Addendum # 2 – Parking Project at John Walter Smith (JWS) Park (Questions & Answers)

Date of Addendum: **August 5, 2026**

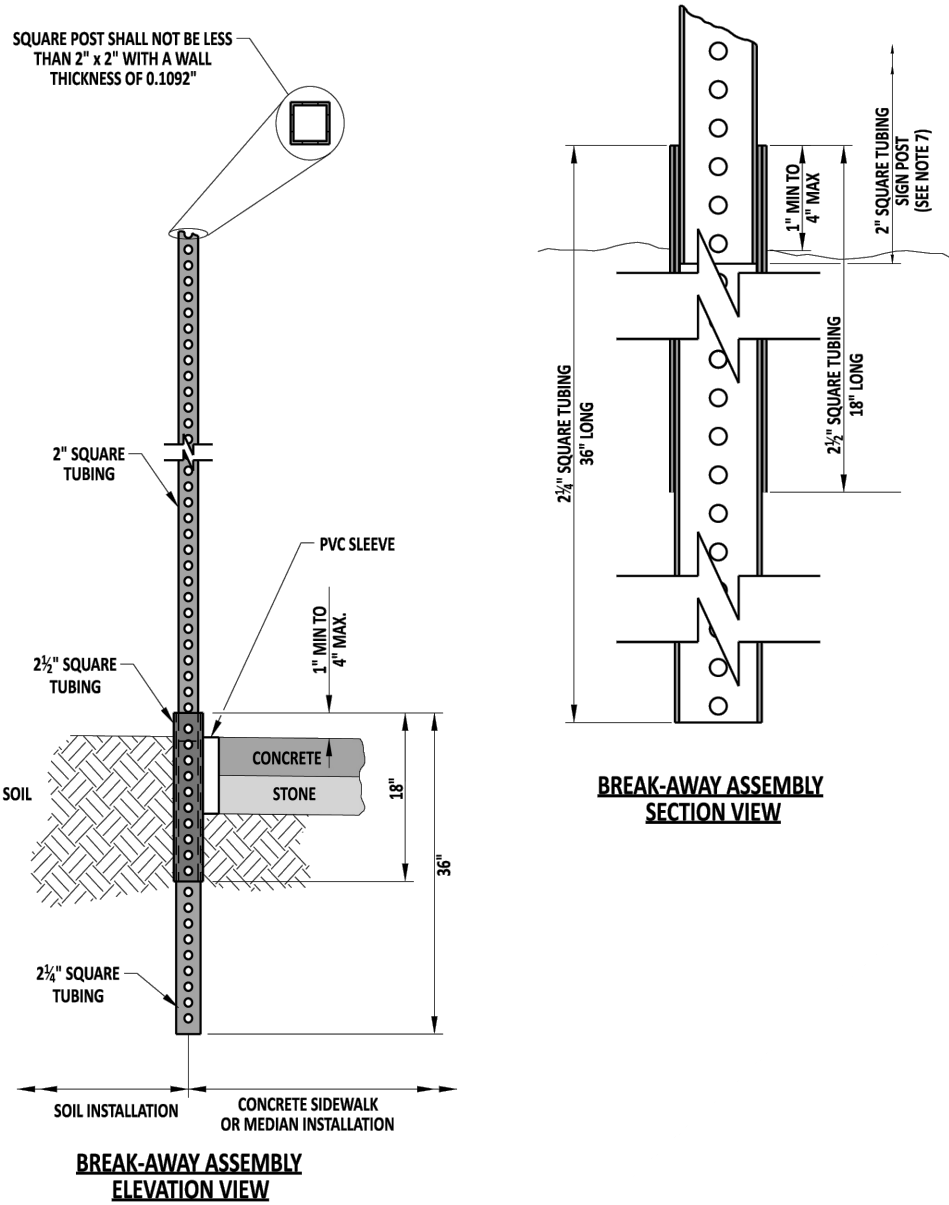
Item	Questions and Answers
1	What class RCP pipe is required for the swale crossings? SD-3 and SD-4 should be class V, all other pipes class IV
2	Does the RCP require flared end sections? If so on both ends or the downstream side only? Yes, on both ends
3	What should the ADA accessible parking signs be mounted on? Please provide details for signpost and embedment. Detail Attached for Breakaway Signpost
4	What mix concrete is to be used for the sidewalk repair? Class A Concrete 4,000 psi
5	Is the County or Engineer providing the SWPPP? A SWPPP was prepared by GMB as a part of the MDE NOI approval process.
6	Please confirm the county landfill will not waive tipping fees for demolition debris. Tipping fees will not be waived.
